**SOLICITATION AMENDMENT
MODIFICATION DE L'INVITATION**

Title - Sujet CCGS Griffon -VLE	
Solicitation No. - N° de l'invitation F7049-200157/A	Amendment No. - N° modif. 014
Client Reference No. - N° de référence du client F7049-200157	Date 2023-07-17
GETS Reference No. - N° de référence de SEAG PW-\$\$MD-029-29039	
File No. - N° de dossier 029md.F7049-200157	CCC No./N° CCC - FMS No./N° VME
Solicitation Closes - L'invitation prend fin at - à 02:00 PM Eastern Daylight Saving Time EDT on - le 2023-08-30 Heure Avancée de l'Est HAE	
F.O.B. - F.A.B.	
Plant-Usine: <input type="checkbox"/> Destination: <input type="checkbox"/> Other-Autre: <input type="checkbox"/>	
Address Enquiries to: - Adresser toutes questions à: Jeddi, Loubna	Buyer Id - Id de l'acheteur 029md
Telephone No. - N° de téléphone (873) 455-3835 ()	FAX No. - N° de FAX (819) -
Destination - of Goods, Services, and Construction: Destination - des biens, services et construction:

Solicitation Amendment # 14

B.1.1 The existing shore power transformer arrangement is shown in Figure 1.

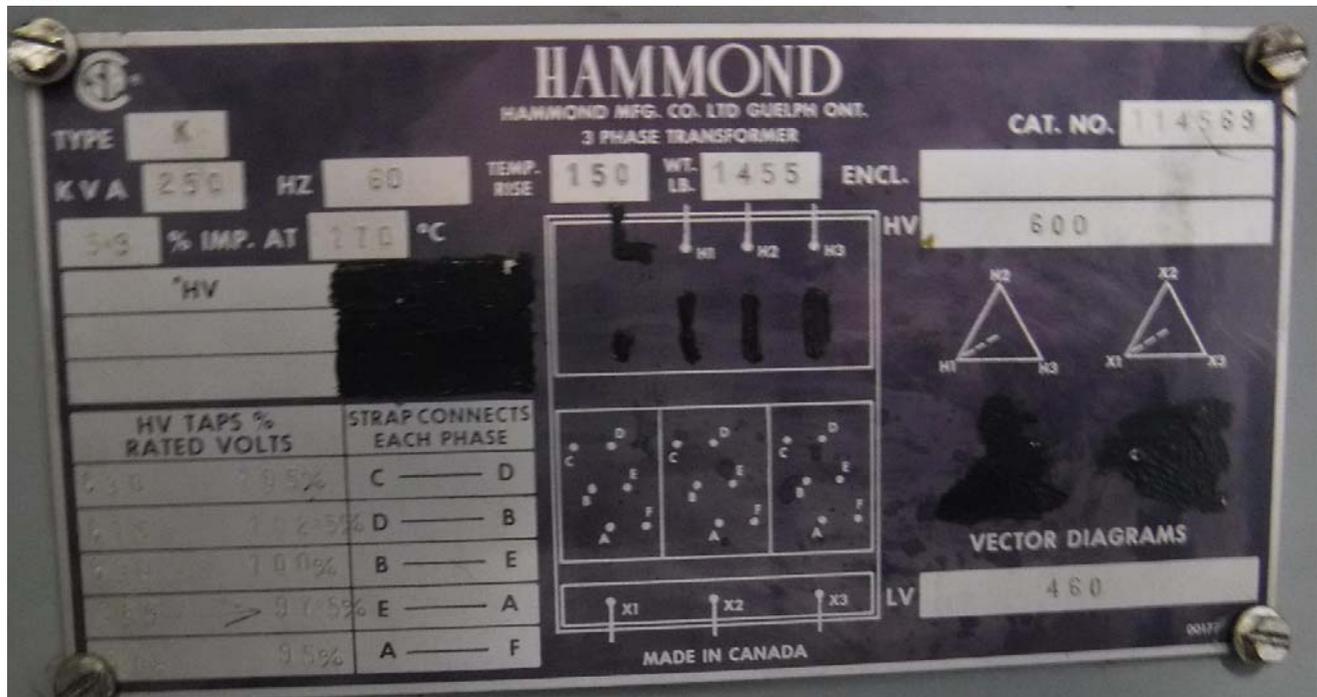
Is it possible to have the nameplate information of the current shore power transformer?

Hammond Type K transformer, Cat No 114569:

High Voltage/Low Voltage:	600 V/ 480 V
Rating:	250 kVA, 60 Hz
Weight:	1455 lbs.
Impedance:	5.3% @ 170°C
Temp Rise:	150°C

High Voltage Taps	Rated
630 V	105%
615 V	102.5%
600 V	100%
585 V	97.5%
570 V	95%
